ADDENDUM #1

CLARKE RANGE COMPLEX LIGHTNING PROTECTION SHELTER BUILDINGS CONSTRUCTION

WBA: 19-054.07

DATE: April 9, 2024

Sheet A1.1 Site Plan – R1

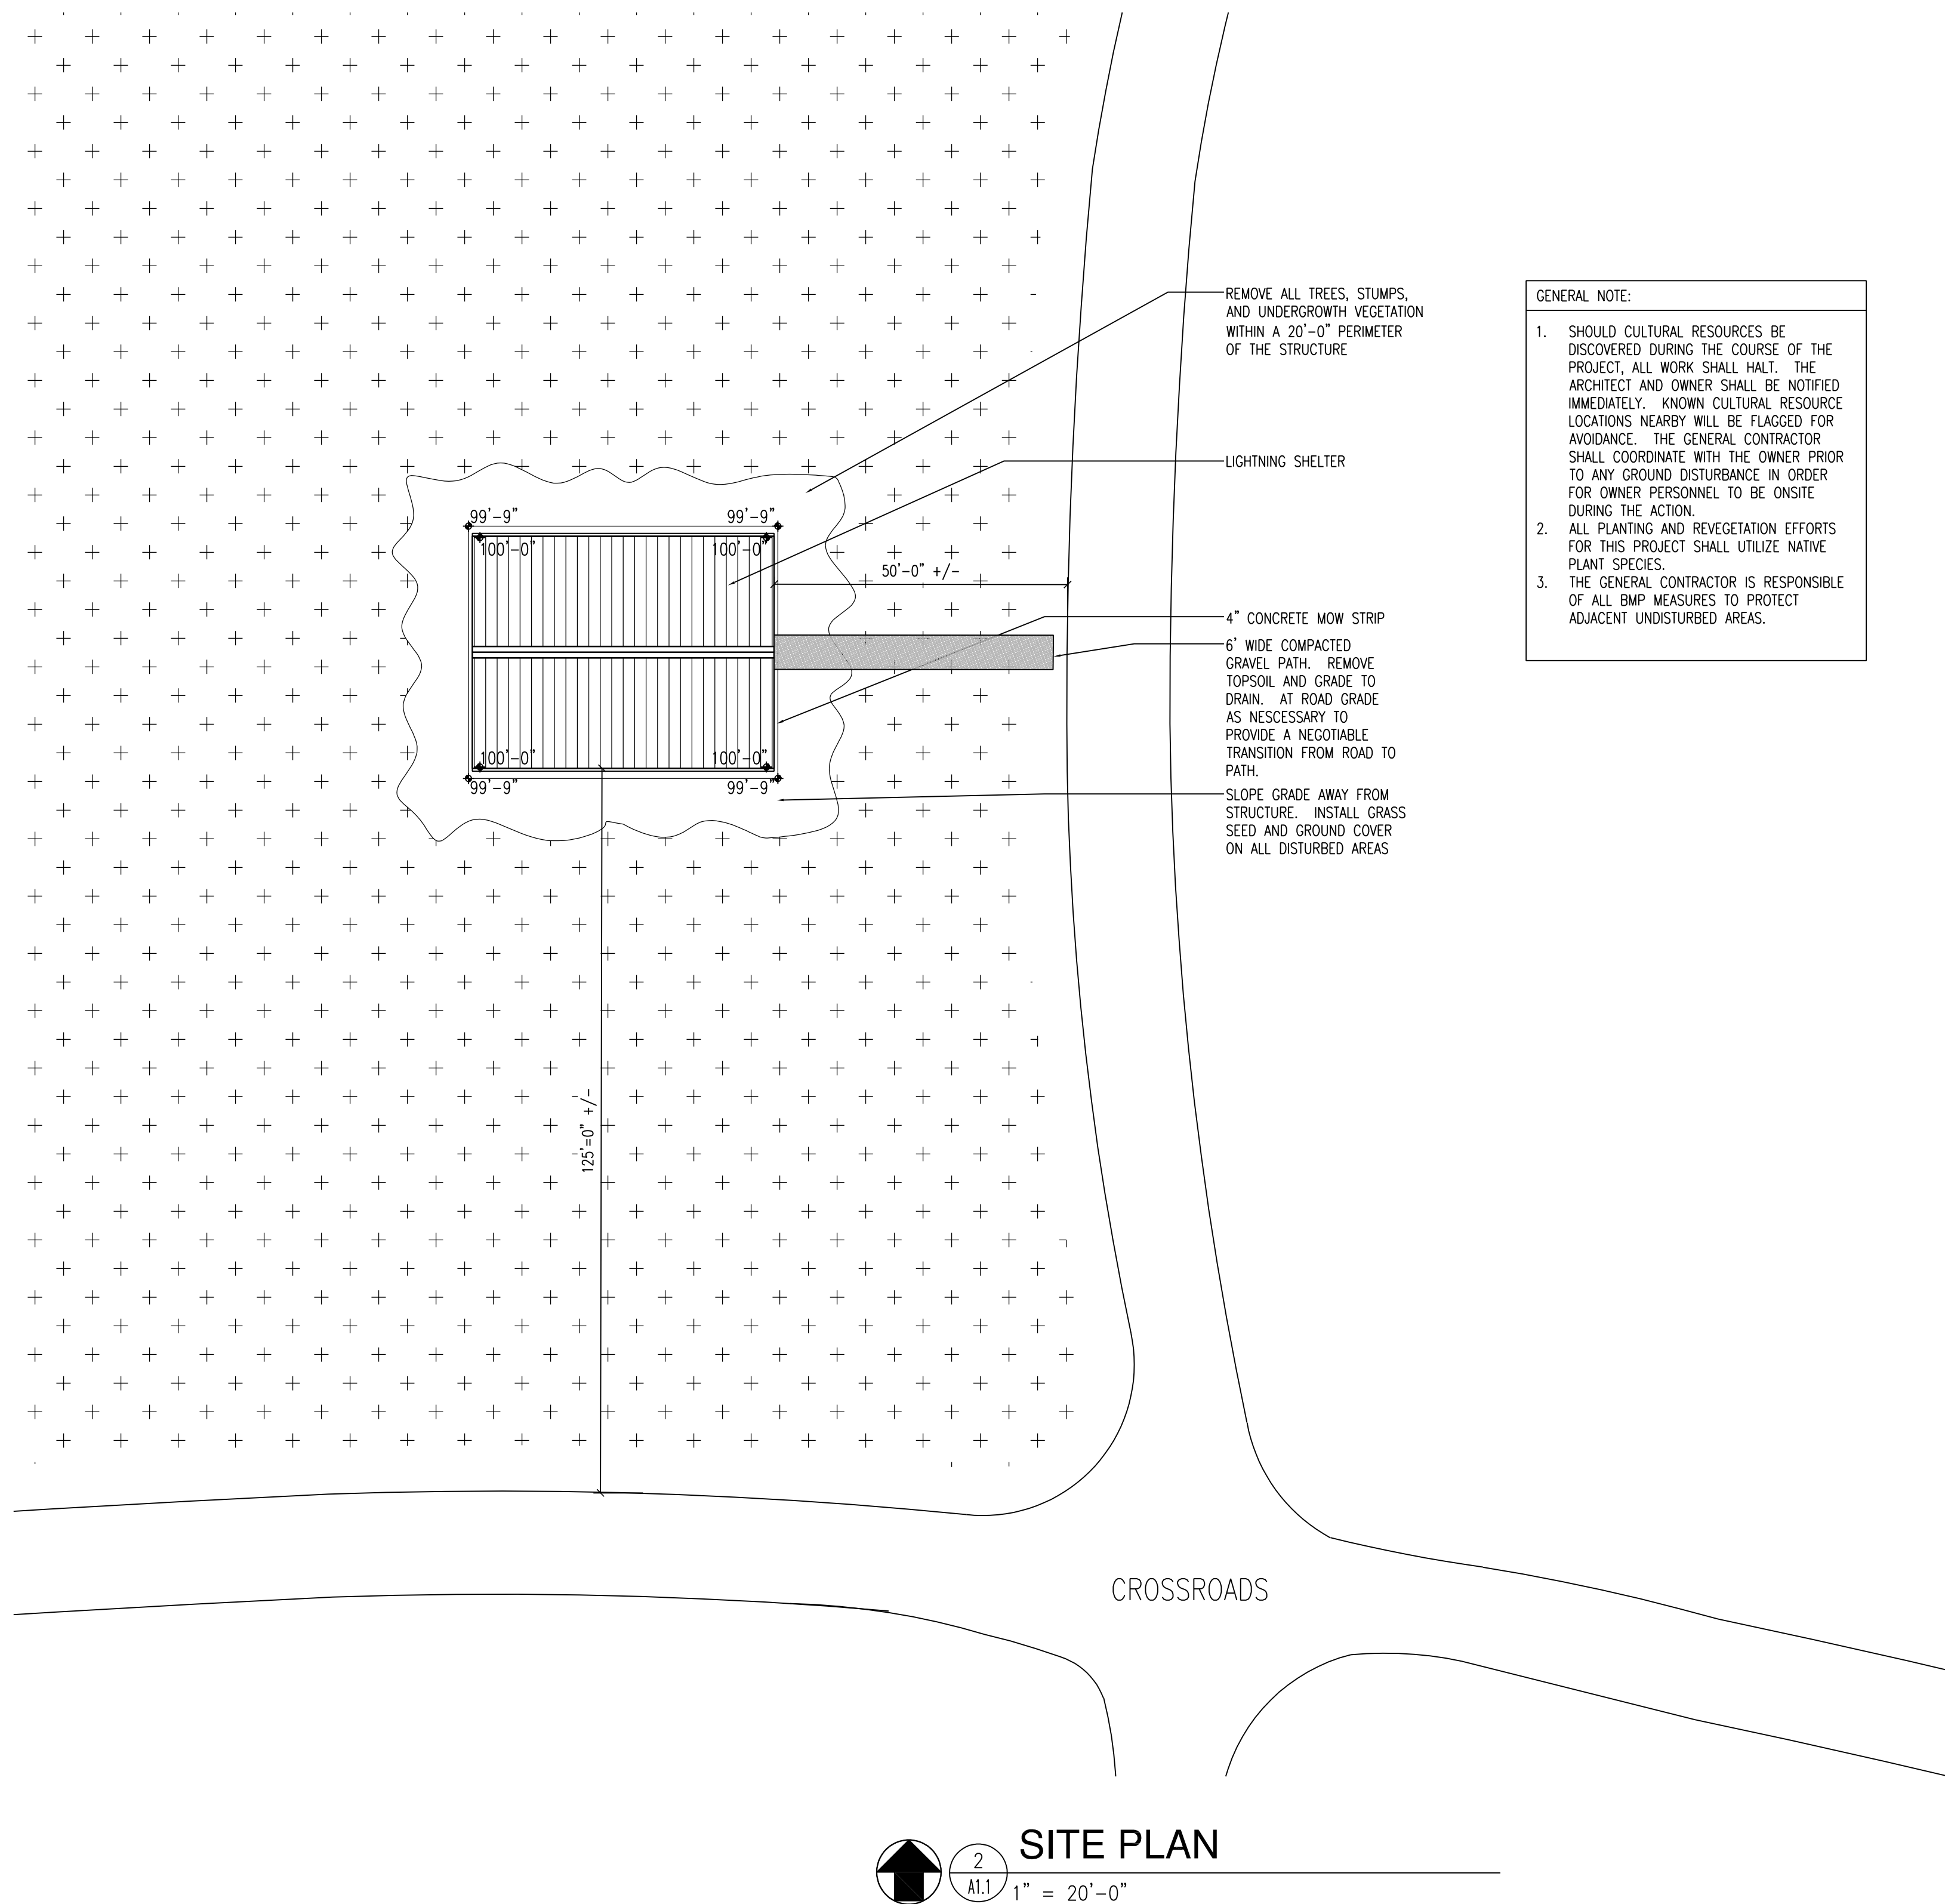
1. Added plan showing approximate existing elevation change across the site.

- GENERAL ELEVATION NOTES:
1. THE ELEVATIONS SHOWN ARE NOT ACTUAL ELEVATIONS AND GRADES. THEY ARE SHOWN FOR REFERENCE ONLY AND TO GIVE AN APPROXIMATION OF THE ELEVATIONS ACROSS THE SITE.
 2. THE GENERAL CONTRACTOR IS RESPONSIBLE FOR PROVIDING ALL GRADING, ENGINEERED FILL, COMPACTION TO PROVIDE A LEVEL BUILDING PAD WITH GRADES SLOPING AWAY FROM THE BUILDING ON ALL SIDES.
 3. THE GENERAL CONTRACTOR IS RESPONSIBLE FOR PROVIDING A WALKWAY FROM THE EDGE OF THE ROADWAY TO THE BUILDING THAT IS SLOPED IN SUCH A WAY THE SITE DRAINAGE WILL NOT ACCUMULATE OR WASHOUT THE WALKWAY.
